STATE OF OREGON  
WATER RESOURCES DEPARTMENT

REQUEST FOR WRITTEN APPROVAL TO USE CONSTRUCTION METHODS NOT  
INCLUDED IN THE RULES AND REGULATIONS PRESCRIBING GENERAL STANDARDS  
FOR THE CONSTRUCTION AND MAINTENANCE OF WELLS IN OREGON

Date: December 7, 1993

Start Card 56029

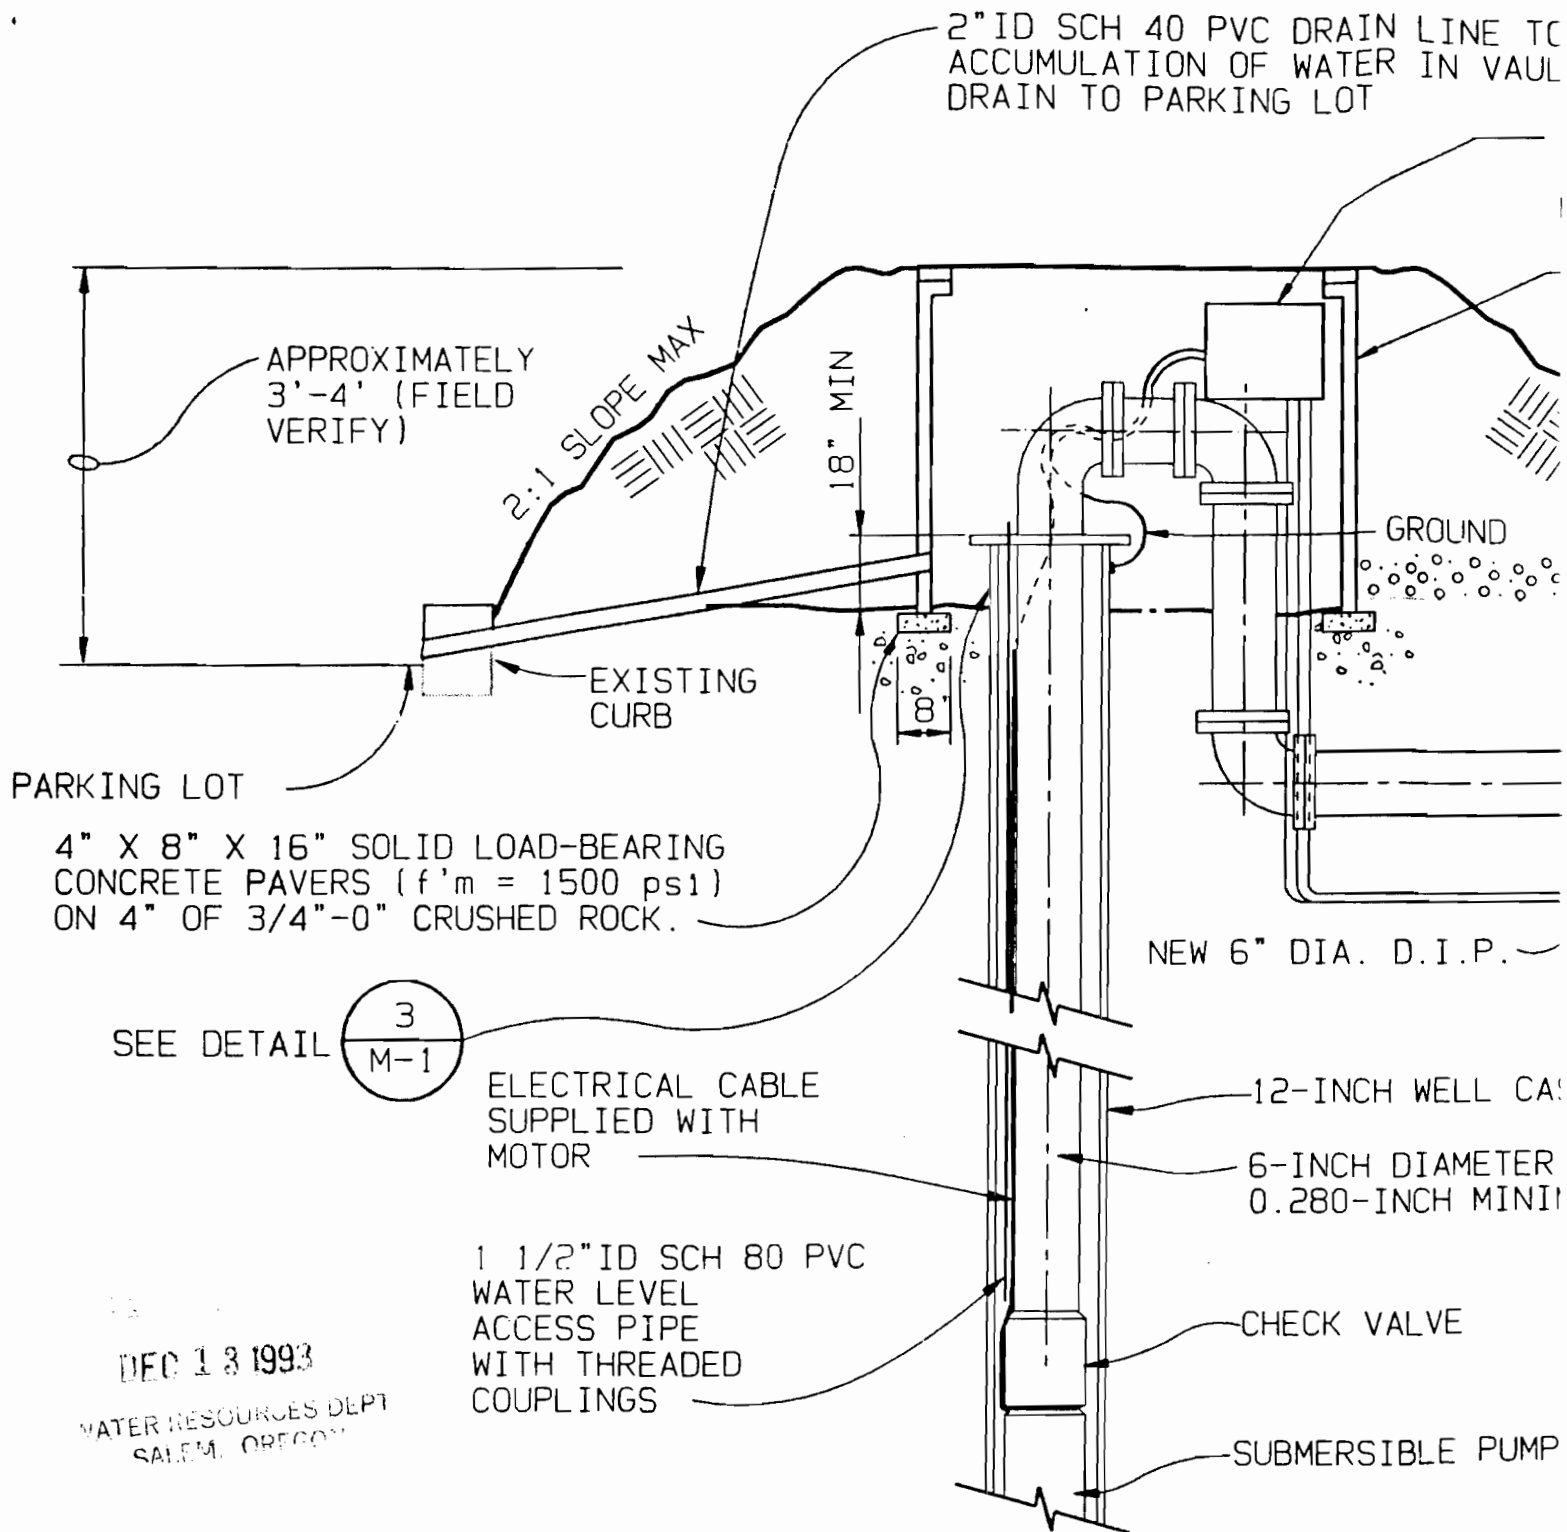
(4) The unusual conditions existing at the well site: Owner wishes to enclose

well head in a vault to protect it from physical harm yet maintain  
serviceability (better than a building!). Filter pack construction  
does not lend itself readily to a pitless unit installation.

Landscape & ground contour raised to facilitate  
installation and assure good natural drainage.  
In addition, vault would also have its own  
drain line to the parking lot. Casing inside  
the vault would still be at least 12" above  
vault floor.

See attached copy of part drawing showing planned construction of well head / vault. Engineering consultant is CH2M Hill

Approved as submitted.
